Subject: AP1000 Response to Request for Additional Information (SRP3.8.4)

AP1000 TECHNICAL REPORT REVIEW

RAI Response Number: RAI-SRP3.8.4-SEB1-01

AP1000 Shield Building (SB) Design Summary:

4.1 Tension Ring / Air Inlet Region

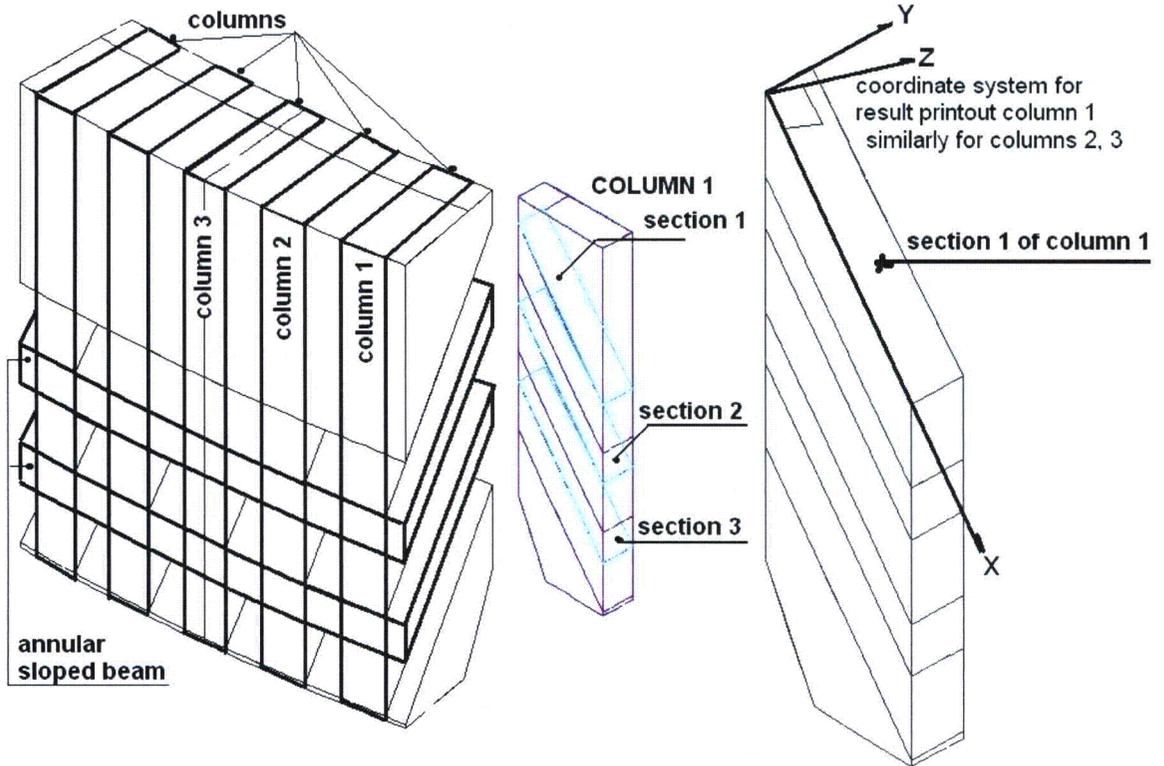
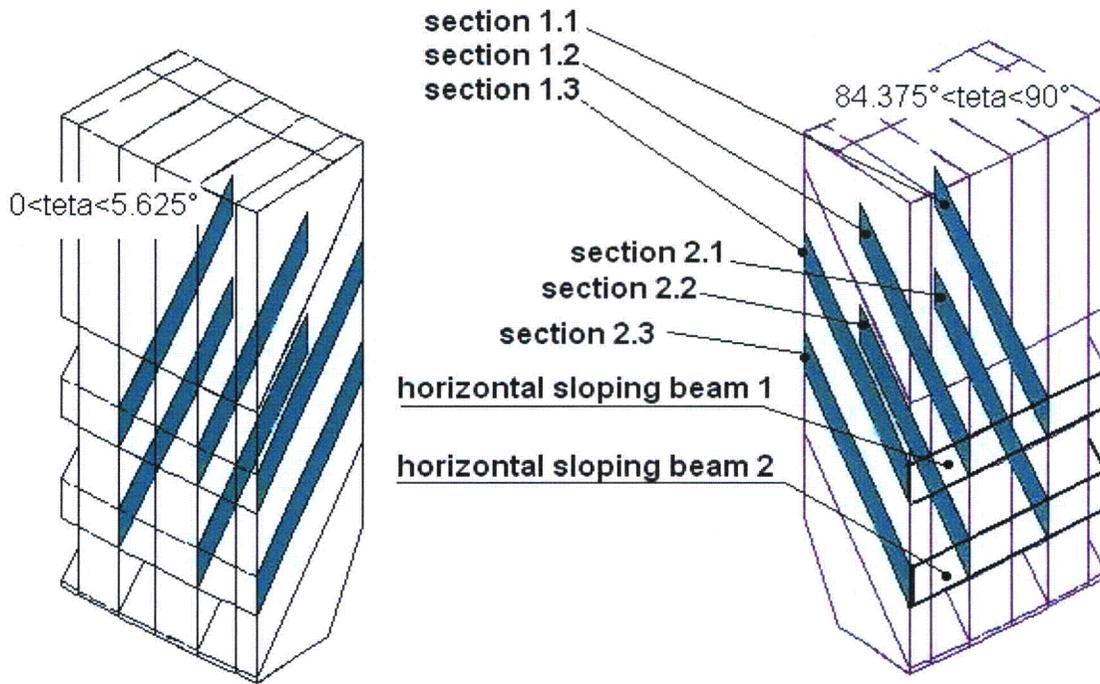
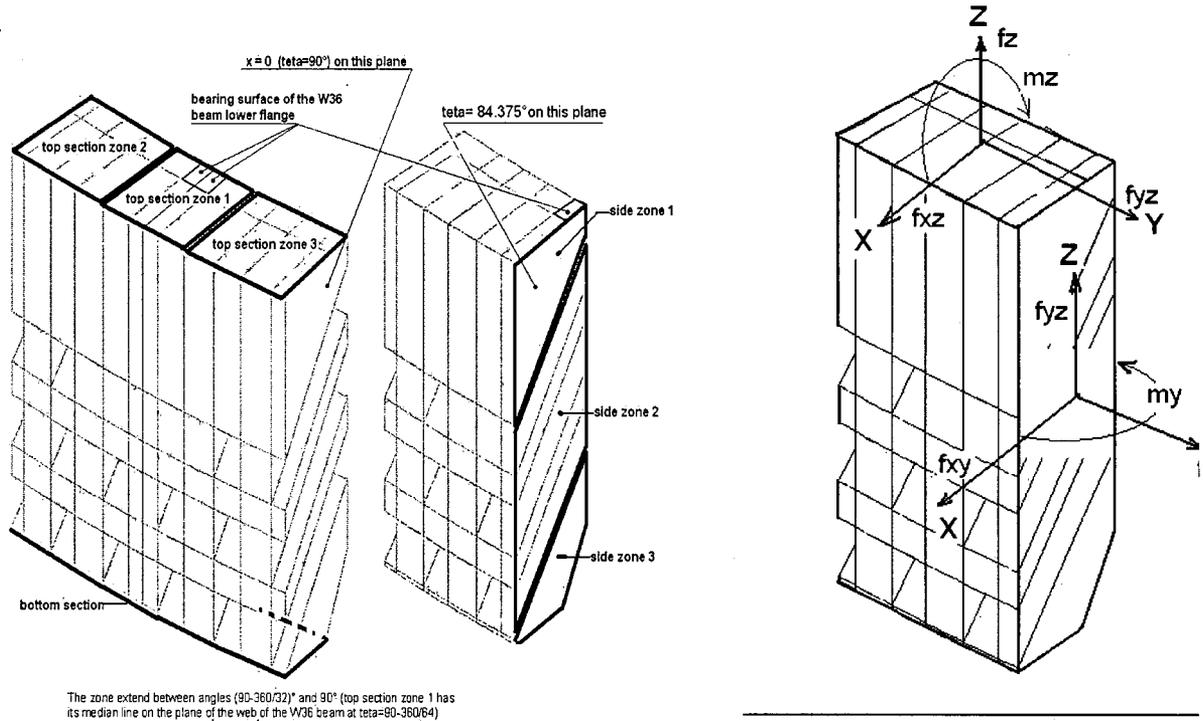
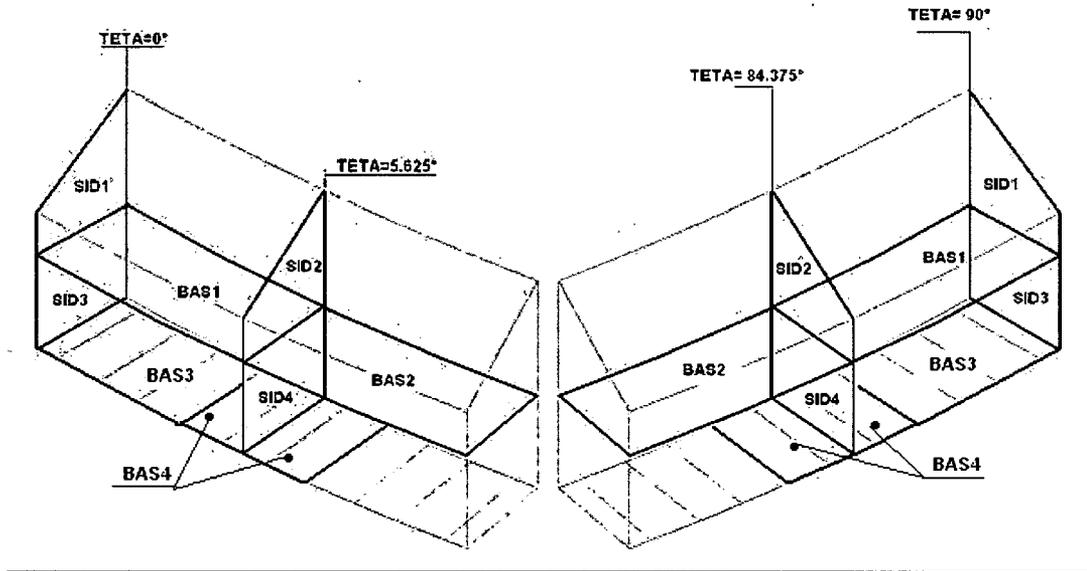
4. Section 3H.5.1.5 states that “A *finite element analysis is performed to determine the design forces*”, but fails to state the method that was used to design the concrete-filled steel cylinder to resist *the design forces*. Therefore, identify the critical regions (elements) of the revised portion of the shield building that are subjected to the largest load combination effects of *the design forces* (bending moment, axial force, and shear force) from your finite element analysis. Describe your design method and state whether the method was derived from, or verified by, test data. If yes, provide the test data. If not, provide the basis for using the design method. Is your design method influenced by the size, length, and spacing of shear connectors? If yes, state the influence of each item. If not, state the reason for no influence. Provide numerical examples, with at least one involves positive bending moment and the other negative bending moment, to illustrate your design method and demonstrate that the critical regions of the revised portion of the shield building can resist *the design forces*.

Figures 1 thru 4 in this document show the details of this region. AS stated above, this region was modeled in great detail in the ANSYS model.

The design of reinforcement in the air inlet region is shown in detail in Figure 2.2-18 (sheet 3 of 7) of TR57. The amount of reinforcement required, and the reinforcement provided, is included in Table 2.2-13 (sheets 1 and 2) of TR57. The tension ring reinforcement calculation is included therein.
